Exhibit 2

Letter from Dr. Michael Peck to Senator
Barbara Boxer (January 22, 2015)

SUBJECT: Continued Failure of the United States Nuclear Regulatory Commission to Enforce Nuclear Safety Rules at the Diablo Canyon Nuclear Power Plant

Figure 1
Comparison of New Gound Motions with the 1977 Hosgri and 1991 LTSP

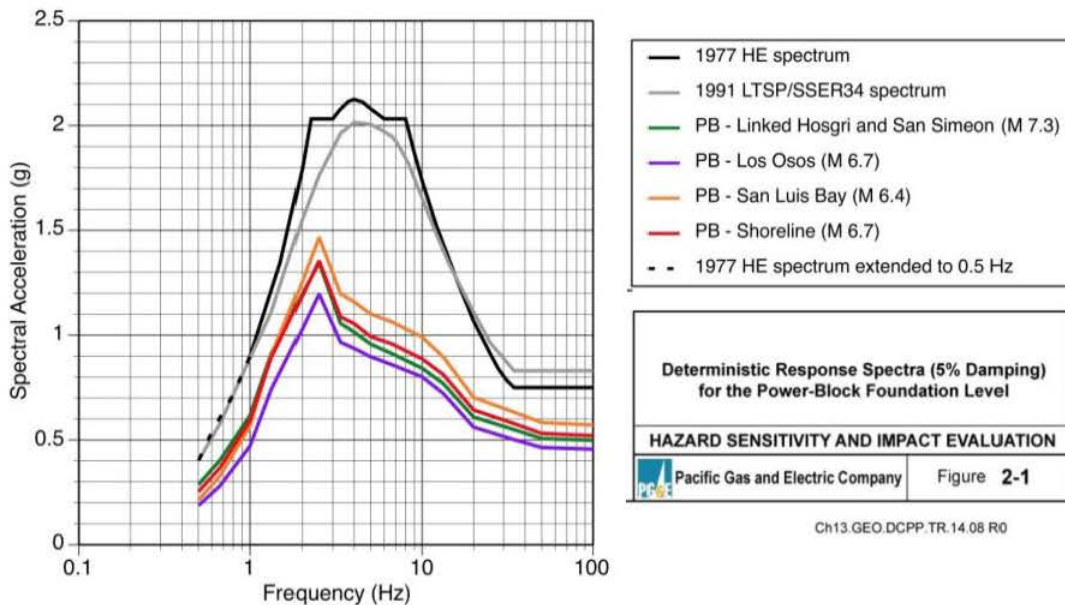
The 1977 Hosgri Spectrum was developed using a 145 km fault length. The new evaluation concluded that the Hosgri has a 171 km fault length.³⁸ The increase in fault length correlates to an increase in earthquake capability. Using CLB methods, the new "PB – Hosgri Linked Spectrum" (shown in green on Figure 1), should have exceeded the 1977 Hosgri Spectrum based on the increased fault length alone.

These new methods were also less conservative when compared to the "1991 LTSP/SSER 34 Spectrum." The 1991 Spectrum (shown on Figure 1) was based on a 7.2 M Hosgri earthquake with a 110 km fault length. The "PB – Hosgri Linked Spectrum" should have exceeded the 1991 LTSP/SSER 34 Spectrum based on the increased Hosgri fault length, if the LTSP Report methods and assumptions had been used.

Without making a judgment of the technical adequacy of the methods reflected in the spectra (Figure 1), these new methods clearly resulted in the analytical results to gain margin. In other words, PG&E's new methods predicted less seismic stress on plant equipment even though the earthquakes are now more severe. The 50.59 Rule required NRC approval of an amendment to the Operating License **before** PG&E was permitted to apply these less conservative methodologies and inputs to facility safety analyses.

Figure 2
Comparison of the Design, Double Design, and Hosgri Seismic Inputs for Steam Generator Qualification

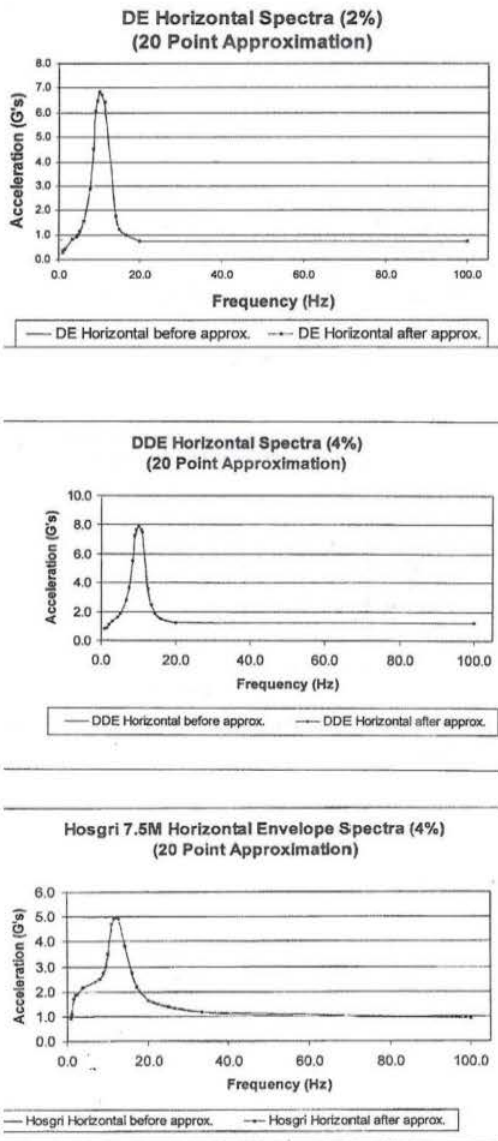
For example, consider qualification of the Diablo Canyon replacement steam generators. As with any plant modification, NRC regulations required that PG&E demonstrate that all Code requirements were satisfied before the reactors are restarted. This qualification process began with the Design, Double Design, and Hosgri ground motion spectra presented in the License Application. Using CLB methods and assumptions, engineers attenuated these seismic inputs to each steam generator. From these attenuation relationships, input spectra (Figure 2) were developed for each earthquake analysis. These spectra represent the levels of vibratory motion (acceleration/stress) affecting each steam generator as a function of harmonic frequency.

The next step in the qualification process was to add the seismic inputs (from Figure 2) to the load combinations specified by the CLB (Cases 1-3). The Double Design load combination (Case 2) results in the highest component stress levels. However, Code acceptance limits are different for the Design (OBE) and the Double Design (SSE)

The Design and Double Design seismic analyses provide very little margin to Code limits, not only for the steam generators but also for other Class 1 components. The unavailability of margin is due to the unusually large seismic loading associated with the original Design earthquake (0.2 g). This affect was also seen in calculations supporting qualification of the replacement reactor heads. For the new heads, the initial design exceeded Code allowable stress on some components for the Design and Double Design Earthquake cases, but not for Hosgri. As a result, PG&E was required to obtain an amendment to the Operating License to allow less conservative safety analysis inputs to complete the reactor head qualification.⁵⁴ The FSAR includes many examples where PG&E to omitted to perform Hosgri qualification calculations based on the much higher seismic loading represented by the Double Design analysis.

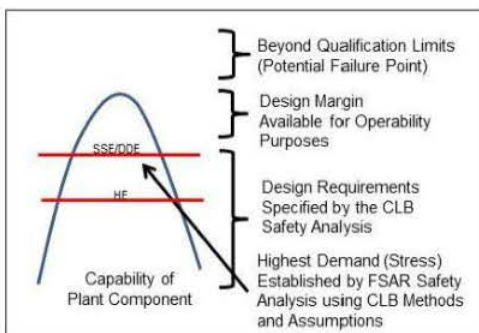
Figure 3a shows the design capability of the component (blue curve) and the level of demand (seismic stress) that the component must be capable of meeting for the Double Design and the Hosgri (red lines) evaluations. As demonstrated with the steam generators, Double Design places a higher demand on the component than the Hosgri. The area above the SSE/DDE demand but below the blue component capability curve is the design margin available for use in operability evaluations.

Figure 3b
PG&E's Use of Hosgri as Alternate Method
for Operability

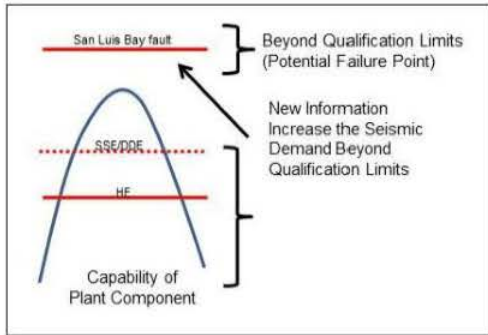
Figure 3.b shows that the San Luis Bay fault (new seismic information) places a higher demand on the component, exceeding the seismic qualification limit. Since the new demand is greater than available engineering margin, the licensee should have declared the component inoperable and applied the Technical Specification required remedial action (reactor shutdown).

PG&E used the Hosgri as an alternate method for demonstrating that the component was operable for the SSE. The operability evaluation stated that because the new San Luis Bay ground motions were less than those used for 1977 Hosgri, then the component was still operable for the Double Design earthquake, irrespective of the actual demand on the component.

PG&E's approach was problematic for two reasons. First, as shown with the steam generator example, seismic qualification is much more involved than just comparing ground motions. The fact that component remained qualified for the Hosgri did not mean that the SSE safety analysis was also satisfied. In fact, in this example the San Luis Bay earthquake (Double Design methods) far exceeded the capability/qualification of the component. Second, the required operability benchmarking would have clearly shown that the Hosgri, as an alternative method, would under-predict the required seismic stress placed on the component when compared to the Double Design methodology.

Figure 3c
PG&E Redefined Safety Analysis Limits by
Changing Methodology and Assumptions

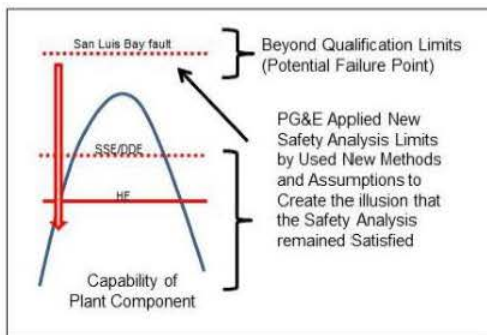
Figure 3.c illustrates the approach PG&E took for 2014 reevaluation. This new information indicated that the San Luis Bay fault also exceeded the Hosgri. PG&E used new ground motion prediction equations and inputs to reduce the amount of seismic energy that was considered to attenuate from the fault to the site. PG&E concluded that the component was operable because these new methods resulted in ground motions that appear less than the 1977 Hosgri Spectrum. Similar to the 2011 operability evaluation, PG&E's new methods inappropriately created the appearance of analytical margin while the actual new seismic loadings exceeded the qualification limits for the component.
